# Access Compliance Report

## Public Rights-of-Way

| Intersection ID: 5515                   | Main Street: NORTHWOODS_FOREST_DR | Cross Street: RUNNING_BROOK_RD | Location: NW                            |
| ADA ID: 34F72ABA0C2A                    | Ramp Type: BlendTrans2            | Initial Pass/Fail: Fail        | Overall Compliance: No                  |

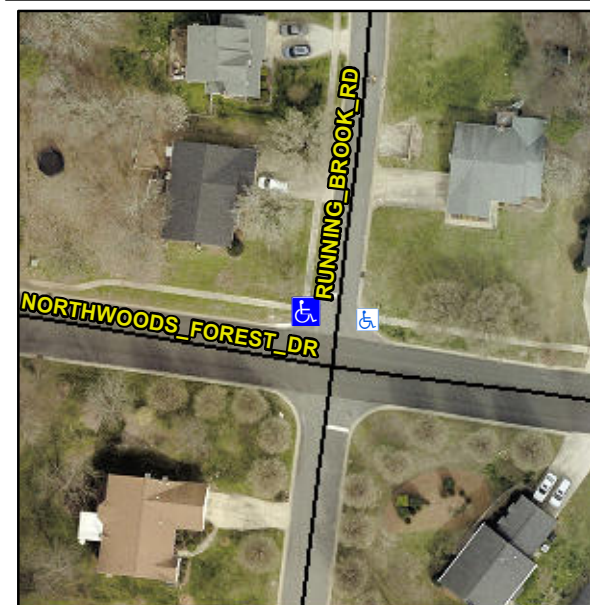
**Not Found, R304.5.3**

| Compliance | Description           | Data | Compliance | Description                 | Data |
|------------|-----------------------|------|------------|-----------------------------|------|
| Yes        | Ramp Width (in)       | 48.0 | No         | BlendTrans XSlope (%)       | 9.0  |
|            |                       |      | No         | Curb Slope (%)              | 16.2 |

**Remove & Replace Curb Ramp With Two New Directional Ramps or Equivalent.**
